1 PCN Information

Title	Product Change Notification		
PCN Number	PCN-2101-TSKL-0005	Issue Date (yyyy-mm-dd)	2021-02-01
PCN Revision	1.0	Effective Date (yyyy-mm-dd)	2021-03-10
Refers to Change Order	ECO-002703	Expiration Date (yyyy-mm-dd)	N/A
Refers to Change Request	N/A	Authors	CJR/FDA

Pre-Conversion	Post-Conversion
Product Name	conga-TS175, conga-TC175	conga-TS175, conga-TC175
Product Number P/N	See Appendix	See Appendix
Serial Number S/N	N/A	N/A
Lot Number	See Appendix	See Appendix
Hardware Revision	See Appendix	See Appendix
BIOS Revision	BxKLR122	BxKLR122
congatec Board Controller Revision	CGBCP439	CGBCP440

BIOS Setup Utility

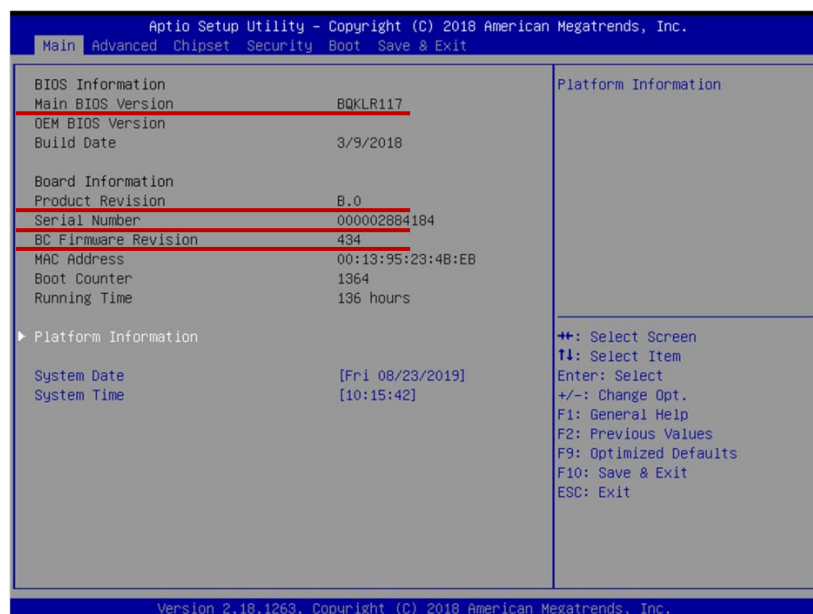
The BIOS can be determined during BIOS POST. The Main BIOS Version, Product Revision, Serial Number and Firmware Revision (Board Controller Firmware) can be determined in the BIOS Setup Utility (Main Menu):
